Warringah Freeway Upgrade
Transport for NSW
Locked Bag 928,
North Sydney NSW 2059

Re: Warringah Freeway Upgrade Place Design and Landscape Plan

Figure 2: Extract from a plan in Chapter 5 of the PDLP showing connections near the replacement Falcon Street active transport bridge. The existing path up to St Leonards Park is marked DDA-compliant which is not correct. This plan does not align with the graphic in Figure 3. (Source: TfNSW/CPBD)

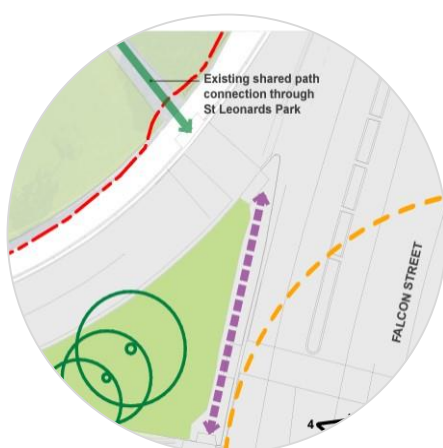
- The scope for the replacement Falcon Street active transport bridge does not include improving the existing crossing of Falcon Street and the motorway off-ramp to reach St Leonards Park. This is a difficult junction to navigate by bicycle and it is a huge lost opportunity not to improve the access as part of the huge NSW Government investment in replacing the bridge. Note that the plan on page 5-37 shows the steep path from the off-ramp crossing into the path as ‘DDA-compliant’ (Figure 2) - this is clearly not correct.

Figure 5: Extract from a plan in Chapter 5 of the PDLP showing connections on the east side of the Ernest Street active transport bridge. It is not possible to cross Ernest St at the desire line that connects St Leonards Park to Anzac Park via Jeaffreson Jackson Reserve (Source: TfNSW/CPBD)

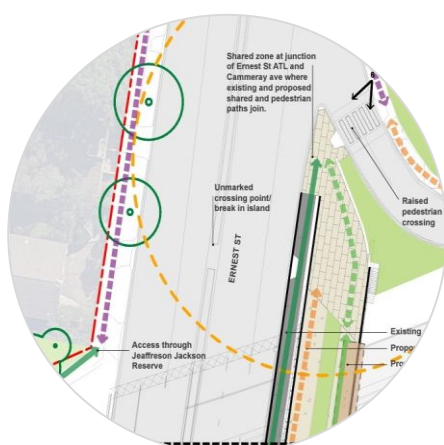
- The crossing of Ernest St at the west end of bridge is shown unsignalised and unmarked on page 5-48 (Figure 5), even though it connects Jeaffreson Jackson Reserve with Anzac Park PS. There is no safe way to navigate this important north-south walking and cycling route without a substantial detour. It is clear that the safety of children has not been prioritised.

Figure 6: Plan of the Cammeray area once the WHT is complete (Source: Acciona)

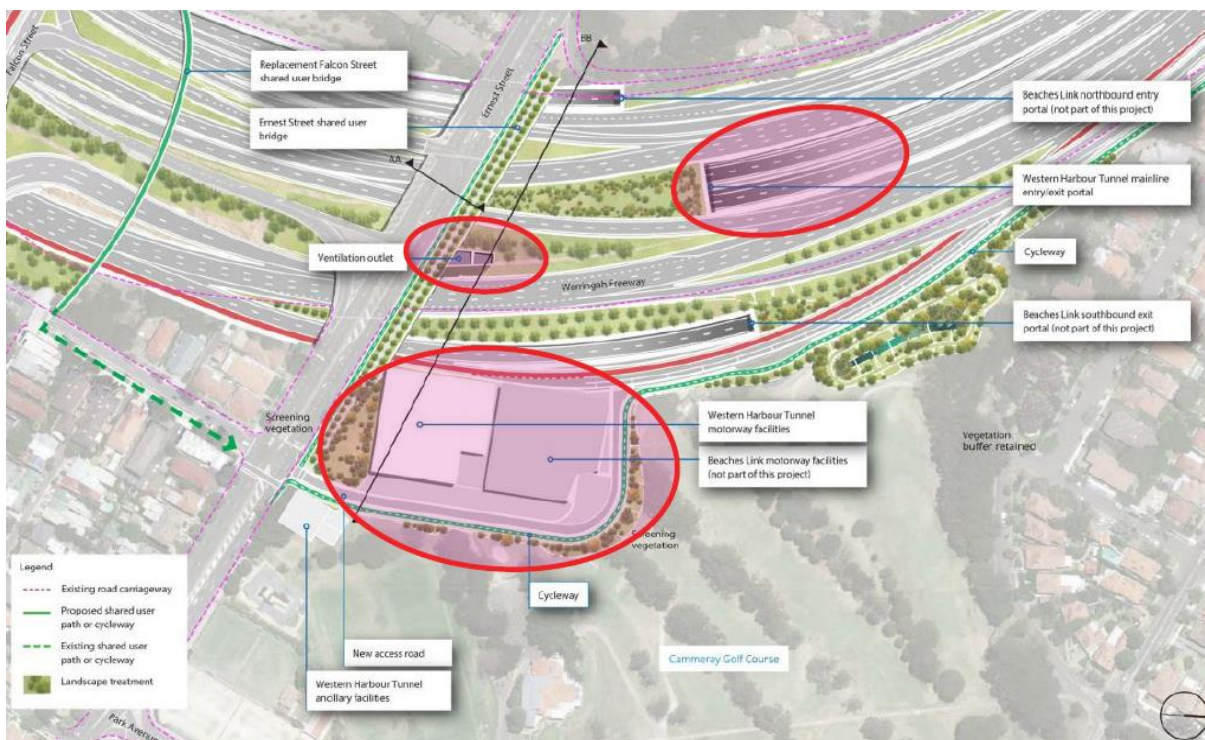
- The separation of the WFU and WHT projects has created confusion about the final configuration of active transport infrastructure. Two very complex projects in a constrained environment with two separated project teams will open up cracks for errors and confusion – both in the documentation and on site.
- The documents should clarify the final outcomes after both projects are complete. Is it currently very unclear what additional impacts the WHT project will have on walking and cycling routes, and if any additional infrastructure will be delivered for active transport.
- For example, the WHT documents include a plan of the Cammeray precinct with a cycleway running behind the motorway facilities and then along the edge of the freeway (Figure 6). The map in the Active Transport Network Review (ATNR) (Figure 7) shows this route as a 'project in development'.

Figure 7: The walking and cycling priorities set out in the Active Transport Network Review indicate that cycleway will be delivered adjacent to the freeway north of Ernest St. (Source: TfNSW)

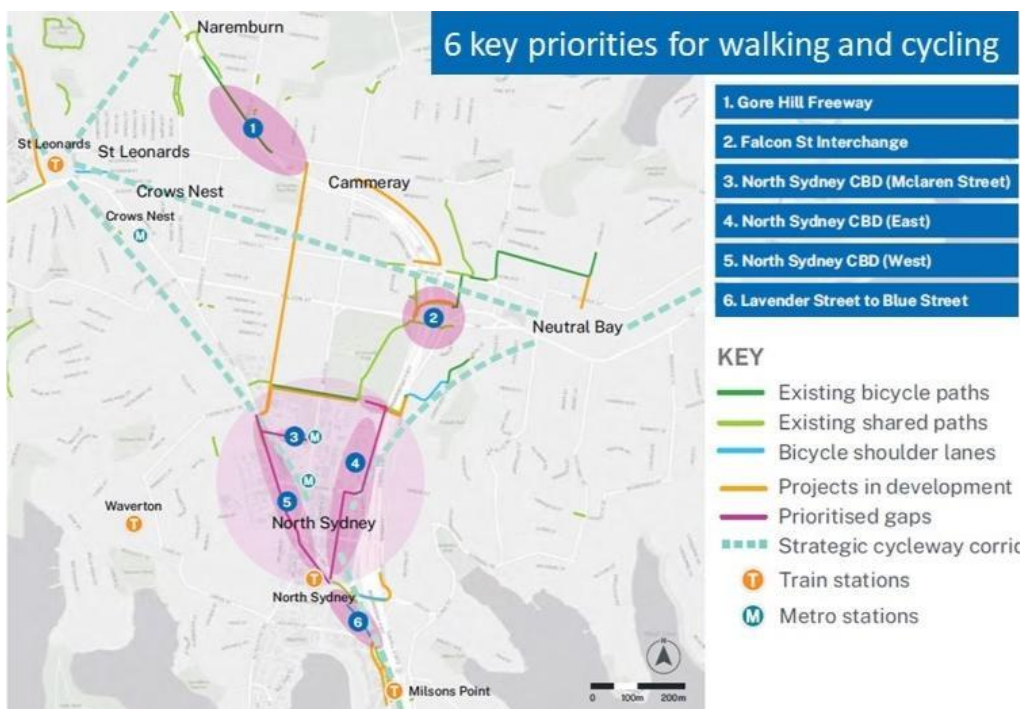
We strongly support the six priorities outlined in the ATNR, as shown in Figure 7. Our submission on the ATNR provides detailed feedback on the routes, and highlights other links that should be considered.

Figure 8: Alterations proposed to Berry St by the WHT project will prevent the improvements to walking, cycling and landscaping that are key to the successful operation of the Metro and other projects (Source: Acciona)

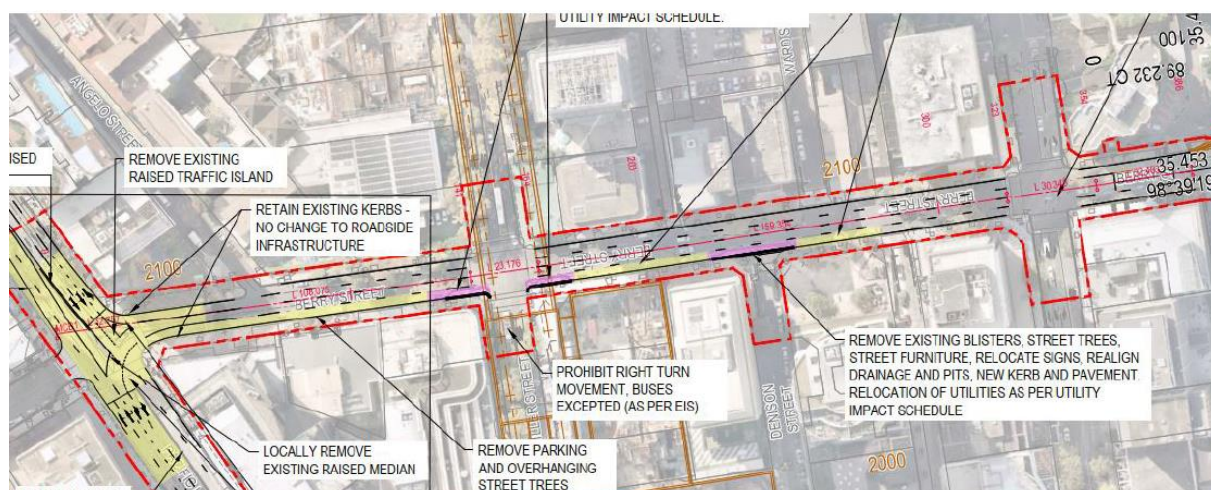
- We have learnt of WHT plans to remove parking, kerb extensions and trees on Berry Street (Figure 8) to create 4 clear vehicle lanes. This does not align with other proposals to reduce the current function of Berry St as a key access route to the freeway. Widened footpaths and landscaping have been flagged to improve place and walkability in advance of the opening of the Metro; a section of separated cycleway is required to deliver North Sydney East priority outlined in the ATNR.
